STATE OF NEBRASKA
DEPARTMENT OF ROADS
ADDENDUM NO. 1
AND
ELECTRONIC BIDDING SYSTEM
AMENDMENT NO. 1
PROJECT NO. EACNH-STPB-30-7(113)
CONTROL NO. 21760
CALL ORDER F06
US-30, IN BLAIR
LETTING DATE: DECEMBER 19, 2002

JUNCTION BOX WITH FLOW ESCAPE GRATE

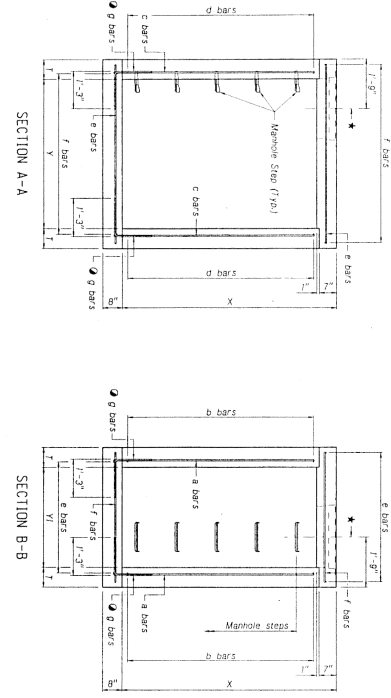
On plan sheet 135, Special Plan 14C is void and superseded by the corrected Special Plan 14C as depicted on the attached sheet.
